**RE: DIGITAL SIGNAGE – M2 MOTORWAY, EPPING  
RESPONSE TO FURTHER SUBMISSIONS BY CITY OF PARRAMATTA COUNCIL**

As requested, please find herein The Transport Planning Partnership (TPPP)'s response to further submissions to road safety queries made by City of Parramatta for the proposed digital signage on the M2 Motorway in Epping.

**Figure 8: Digital Signage and Variable Speed Signs on M4 Motorway**

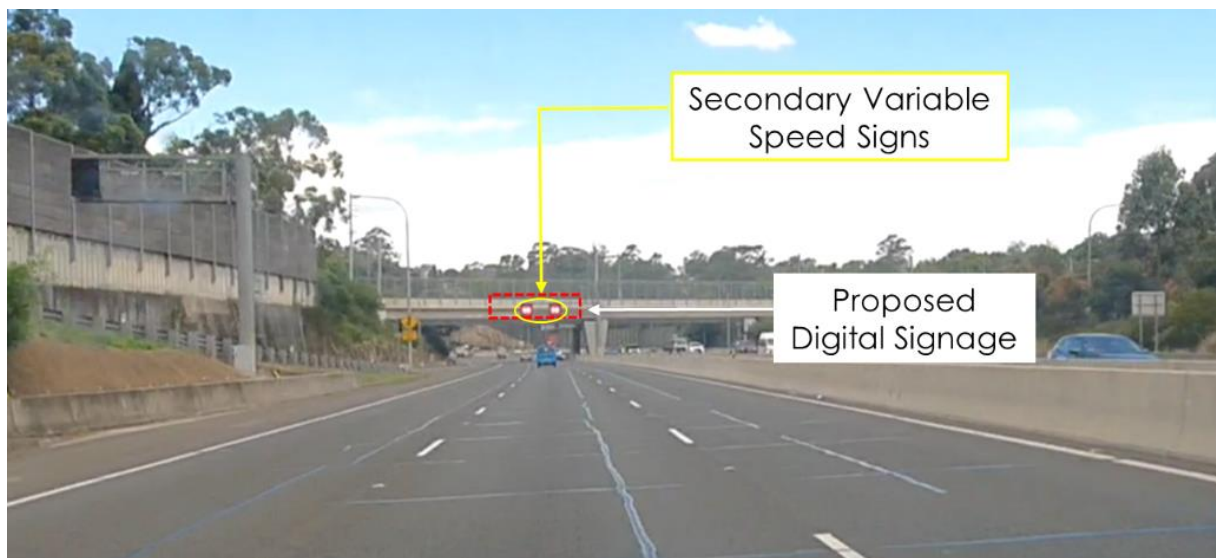
- ***The Traffic Consultant for the applicant argues that only the secondary Variable Speed Limit Signs (VSLS) are affected by the proposed advertising sign. Furthermore, they argue there will be minimal overlap with the VSLS in the foreground to be obscured by the digital sign. This point is disputed considering the VSLS is located only 35m from the proposed sign meaning that both signs will be in view of the driver for essentially the entire approach. This point is demonstrated in figure 2 above [provided in Attachment Two].***

It is noted that the secondary VSLs may be, at times, positioned in front of the proposed digital signage. However, the speed signs would not be obstructed by the digital signage and the VSLs would be visible to motorists at all times (see Figure 8). The earlier M4 Motorway example demonstrates how variable speed limit signs can be located prior to a digital signage without causing visual impediment (see Figure 9).
